**FILE:** D/2017/469 **DATE:** 19 February 2018

**SUBJECT:** Information Relevant To Item 9.5 – Development Application: 9 Doody

Street, Alexandria - At Council - 19 February 2018

# SWEPT PATH ANALYSIS OF SERVICE VEHICLE

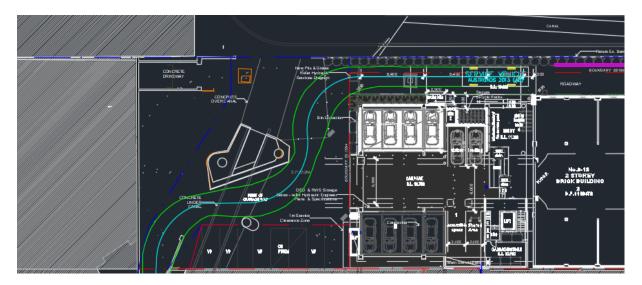
Vehicle swept paths show that service vehicles will stray onto adjacent land in order to pass through the site. They have no permission to do so.

**Comment:** Further swept path analysis has been submitted by the applicant to demonstrate that a service vehicle can service the site and remain wholly within either the subject site or within the boundaries of adjacent sites that are burdened by an easement for access. A copy of the further swept path analysis is provided at Attachment A.

The above is a swept path analysis for a service vehicle passing through the rear of the site. It's evidence that a vehicle can pass through the rear of the site without relying on a neighbour's property where no easement is in place.

The blue line indicates the extent of the easement over 32 Ralph Street, the green lines indicate the extent of the service vehicle.
